NIBLEY CITY COUNCIL MEETING AGENDA Thursday, February 16, 2017 – 6:30 p.m. Nibley City Hall 455 West 3200 South, Nibley, Utah

Nibley City Council Agenda Report for February 16, 2017

Description	Discussion and consideration of a building design and site plan review for Heritage Vet Clinic/Kennel located at 2365 S Heritage Drive
Department	Planning
Presenter	Stephen Nelson, City Planner
Applicant	Jim Miller
Background	By way of general comment, in the past, when a site plan has been for a single, small building, the opinion and direction of the Council and Planning Commission has been that a concept presentation could be waived and that preliminary and final site plan could be done as one approval. The approval being requested at this time is the final site plan and building design.
	Heritage Vet Clinic/Kennel is a small-animal vet clinic being proposed to be constructed at 2365 S Heritage Drive. This property is zoned Commercial. A small-animal vet clinic is listed as a conditional use in the commercial zone. That conditional use permit is not on the agenda at this time and would be considered by the planning commission at the time of businesses licensing.

EXTERIOR ELEVATIONS

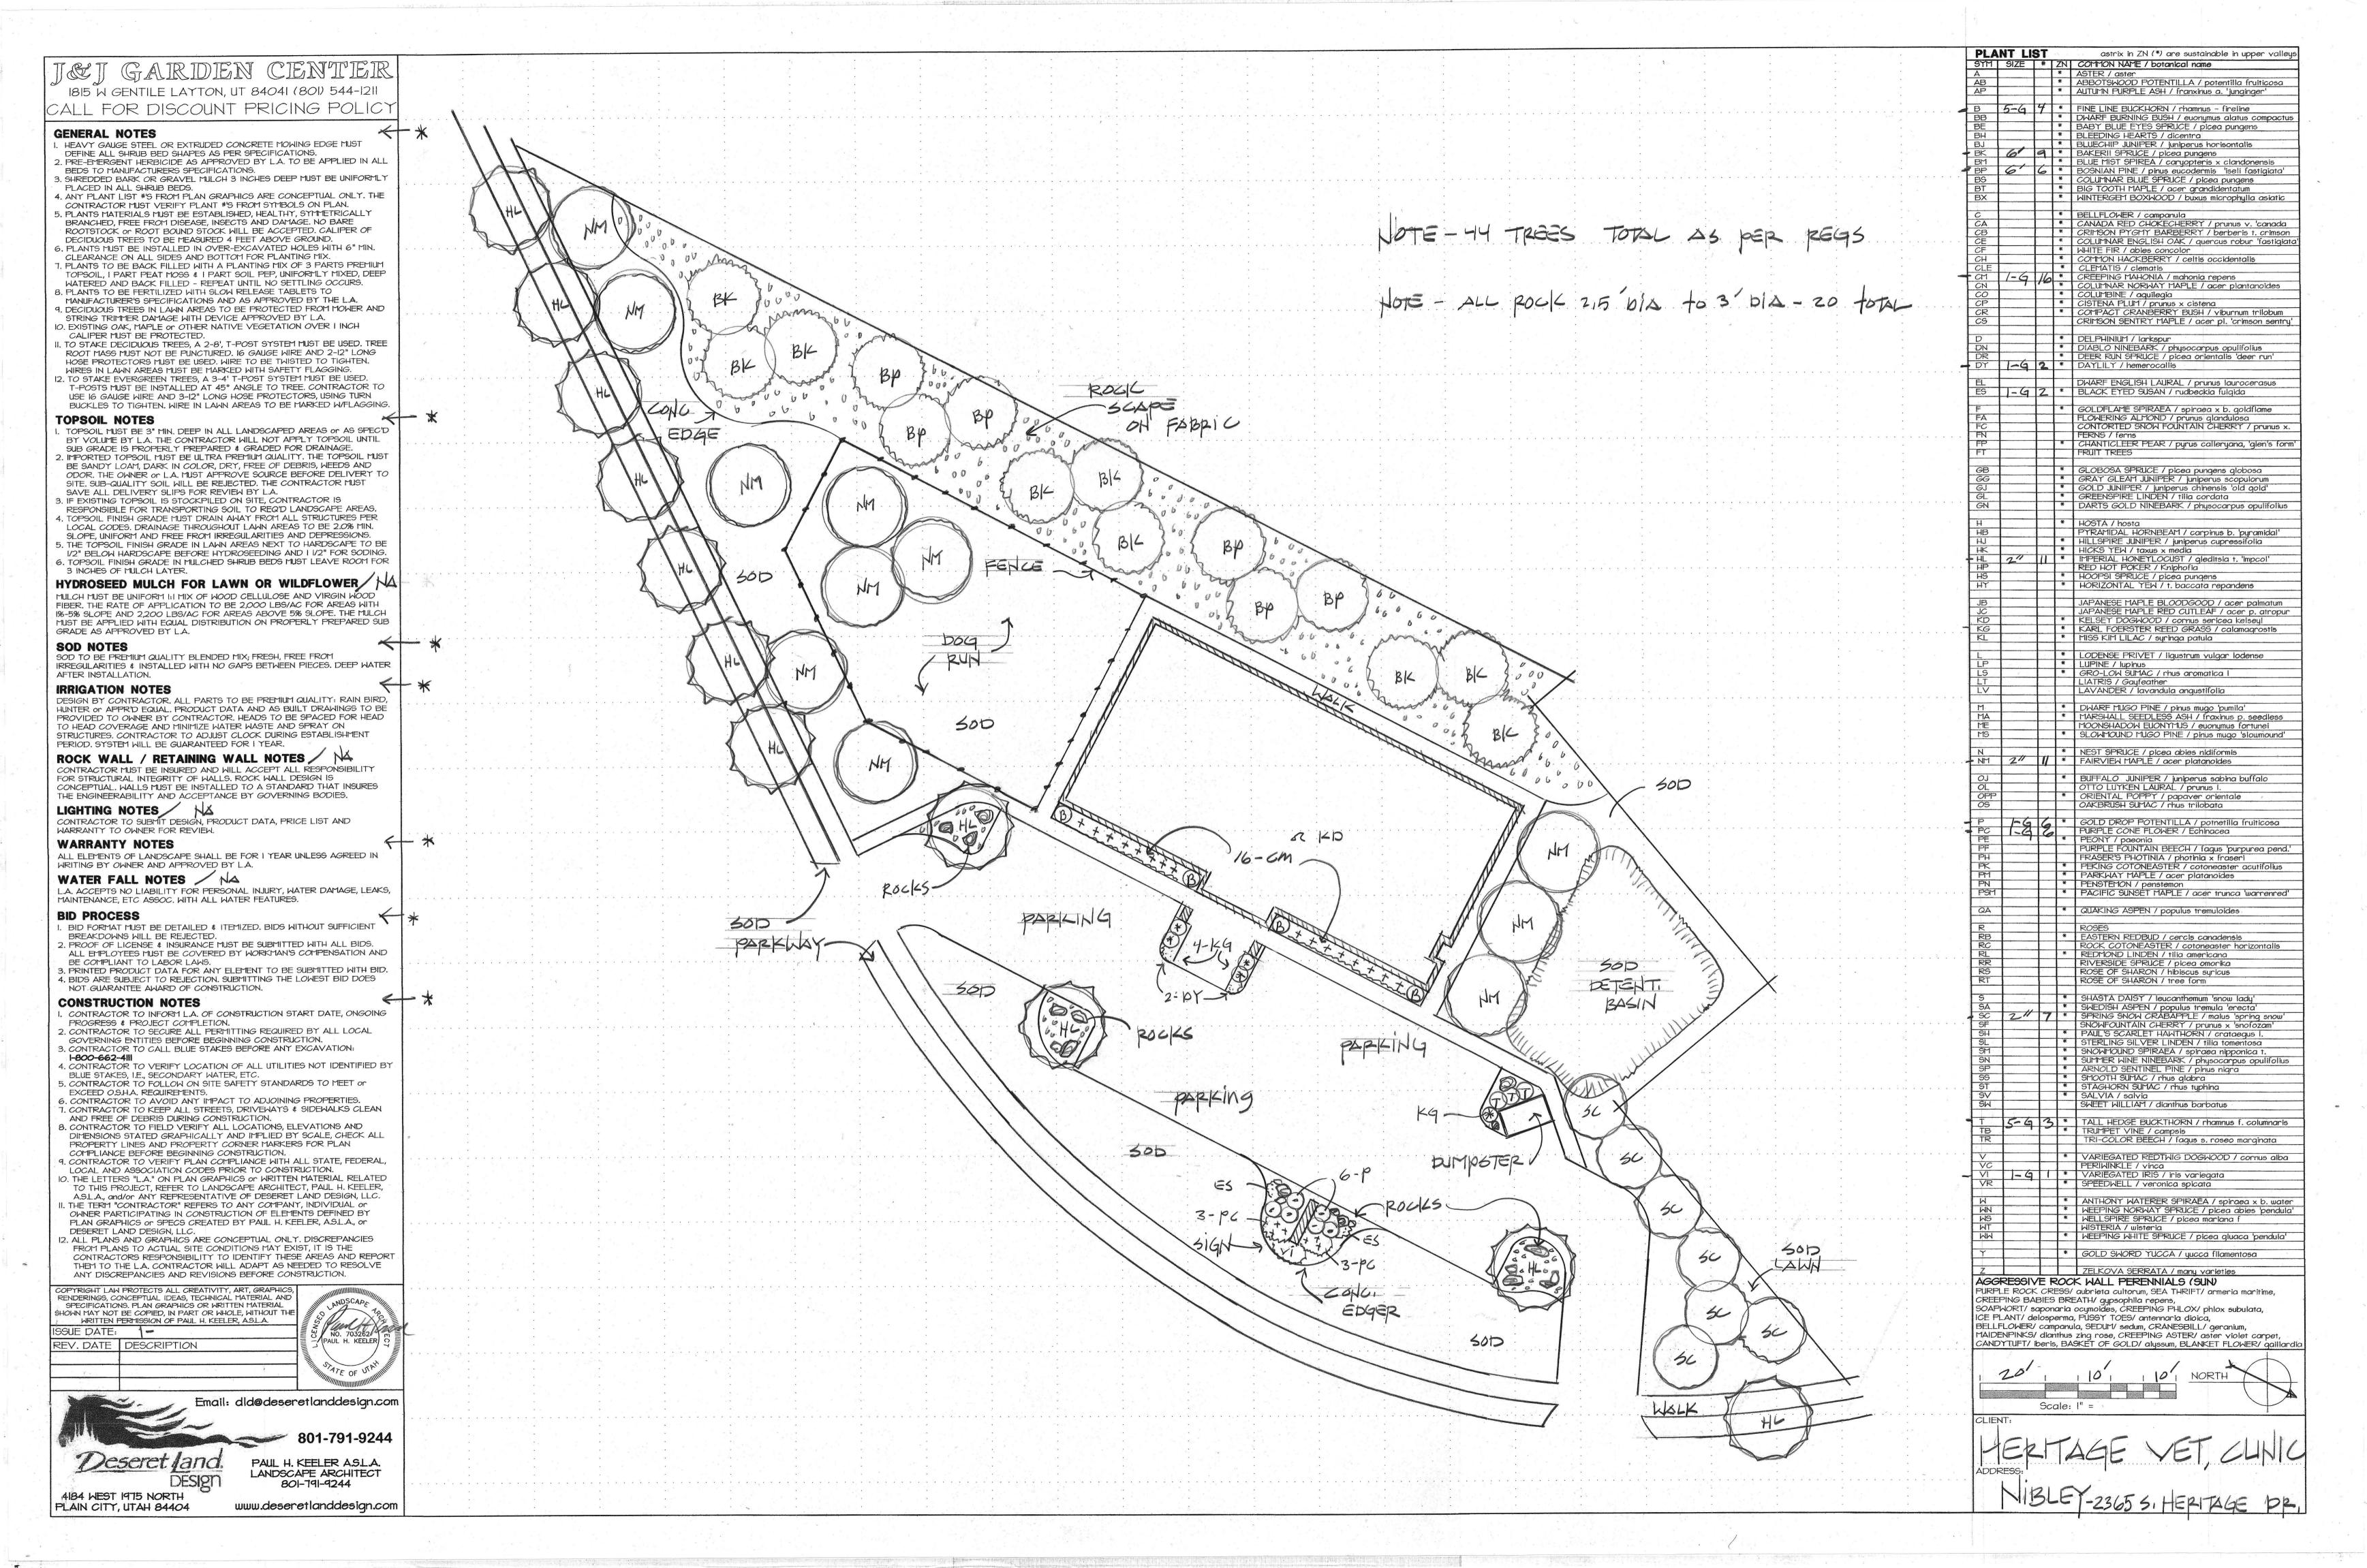
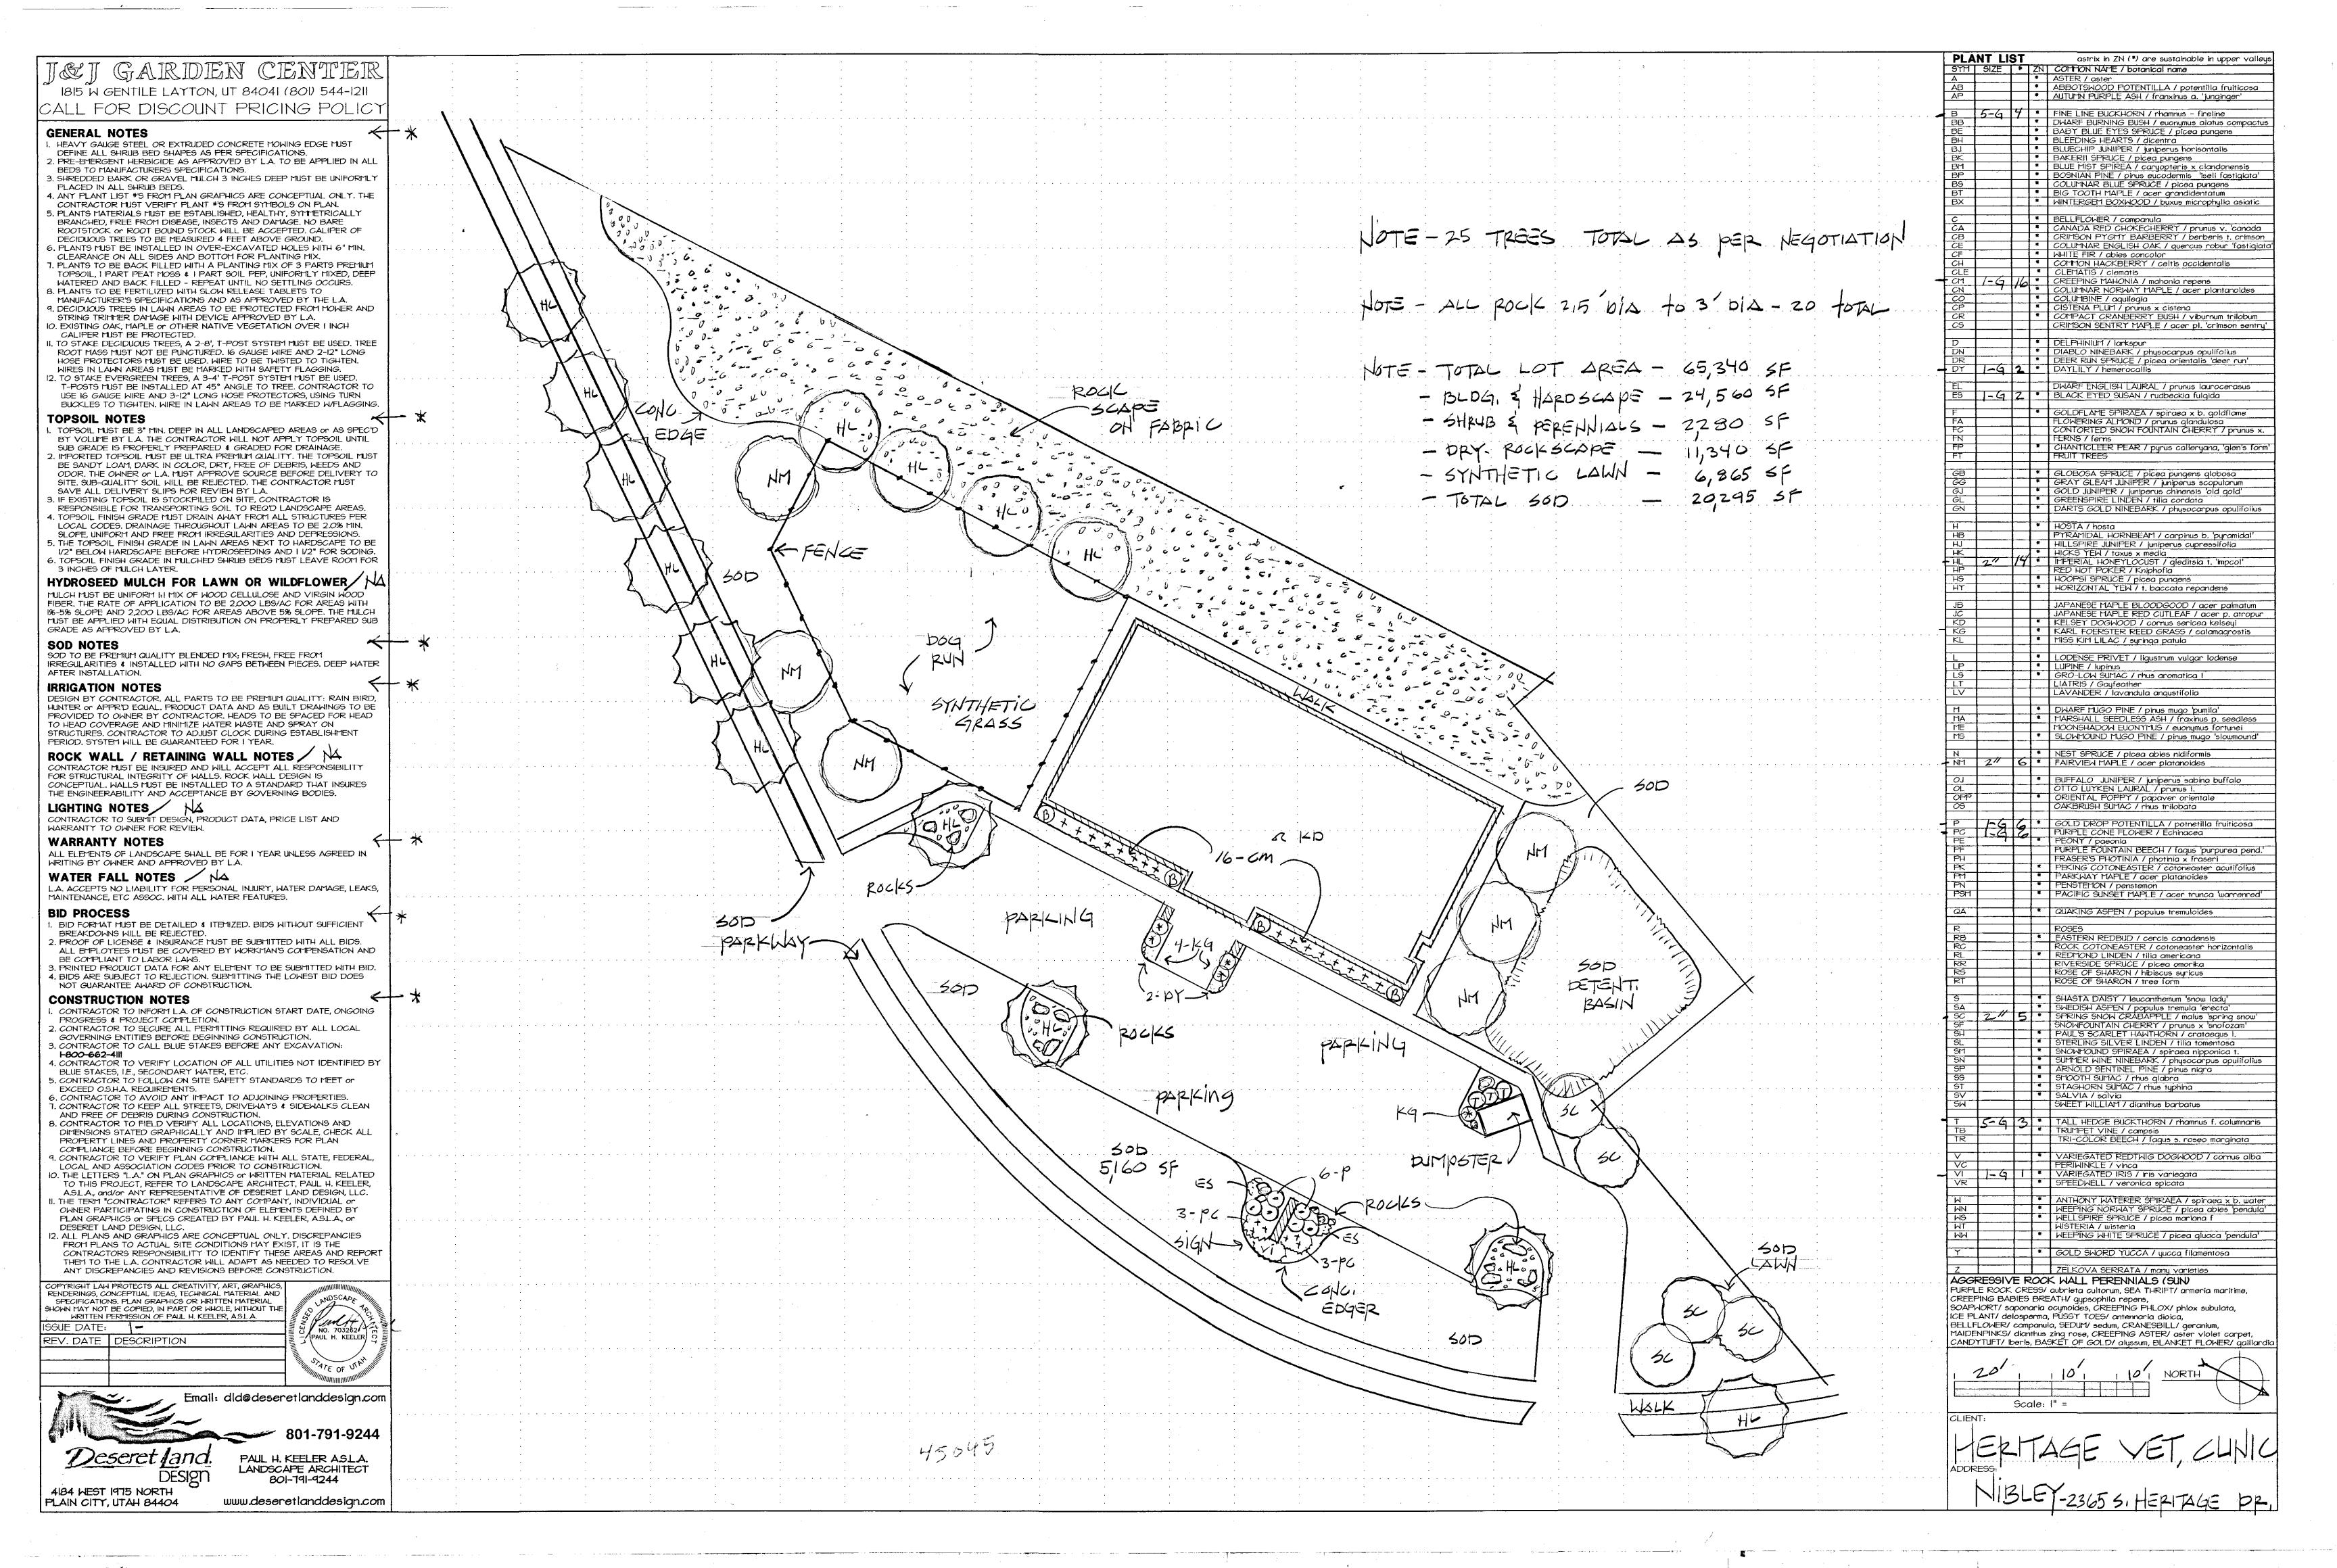
Currently, along the front elevation, the gross exterior façade is 1,157 sq. ft. and fenestration is 482.5 sq. ft. with a total of 41.7%. Nibley City Design Standards for Commercial Building requires that that front façade of commercial building has at least 60% fenestration. The building does not comply as proposed and will need to be addressed.

The standards do give the governing body some discretion and flexibility to apply the code differently for unique developments. Staff has provided a letter to the Council from the property owner addressing these concerns and asking for deviation from the standard. His primary reason for the request is privacy and safety for the animals. It is staff's opinion that the design of the building matches the intent of the law and will match the surrounding development. The Planning Commission waived the requirement for 60% fenestration at the façade of the building on January 25, 2017.

grant a variance to these standards at their discretion. The Planning Commission waived the requirement for 60% fenestration at the façade							
	of the building on January 25, 2017	-						
Recommenda	Approve the proposed site plan and design, with a modification of the 60%							
tion	fenestration requirement down to 40% ar							
	trees in the landscaping along the sewer e							
Reviewed By	City Planner, City Manager, City Engineer, City Building Inspector, Nibley City Plannir	•						
	City Dullang inspector, Misicy City Flamin	19 001111111331011
